# Work Order ID 89400

Item Name: Bearing Assembly

DRAWING NO. D3183	TITLE BRACKET ASSEMBLY	REV.C1	DART AEROSPACE LTD ENGINEERING ORDER		D.E.O. NO. D3183-C1-1	SHEET NO. SHEET 1 OF 1	SCALE NTS
DRAWN <i>JP</i>	CHECKED <i>JP</i>	MFG. APPR. <i>MA</i>	APPROVED <i>JP</i>		DE APPR. <i>JP</i>		
DATE 10.05.14	DATE 10.06.30	DATE 10.06.30	DATE 10/06/30		DATE 10/06/30

#### **D3183-5 BEARING: SPECIFICATION CONTROL DRAWING**

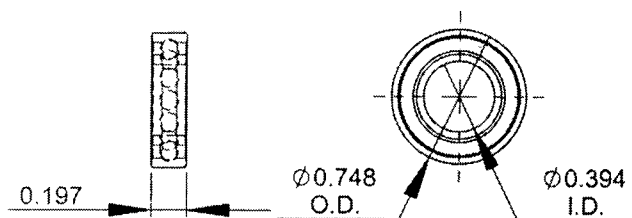
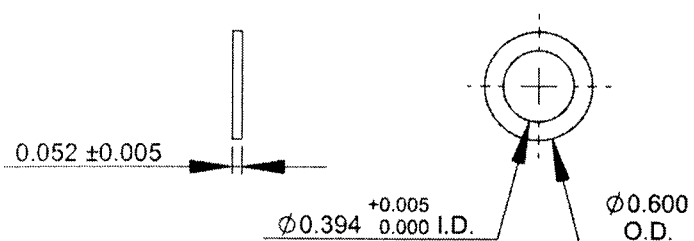
ADD POSSIBLE SUPPLIER: KML P/N 6800-ZZ

**BASIC LOAD RATING REQUIREMENT:** Cr = 1720 N (386 lb) MIN [DYNAMIC]  
Cor = 840 N (188 lb) MIN [STATIC]
